BUILDING CODE OF AUSTRALIA Audit Report

200 Burwood Highway, BURWOOD VIC
3125

This report provides a BCA compliance review of the United Energy Burwood Depot Site. The report nominates relevant BCA prescriptive or 'deemed to satisfy' compliance provisions and possible areas in which alternate performance based design solutions can be adopted where compliance with the nominated prescriptive provisions may not be practically achievable.

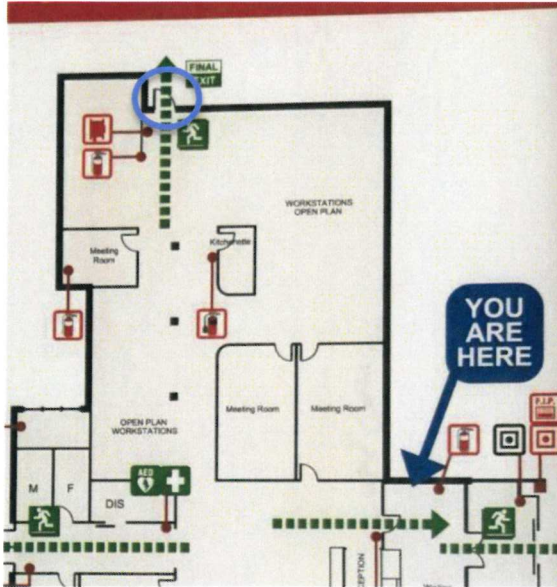
Latch side clearance is not provided to accessibility facility

Non compliant full height glazing must have decals compliant with AS1428.

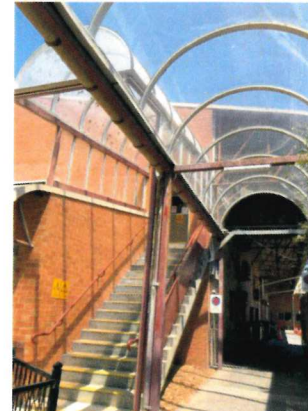
Currently there the front admin / office building is connected to the rear maintenance / stores building via a covered walkway. This covering appears to be a combustible material.

There is no separation between buildings due to the covered walkway.
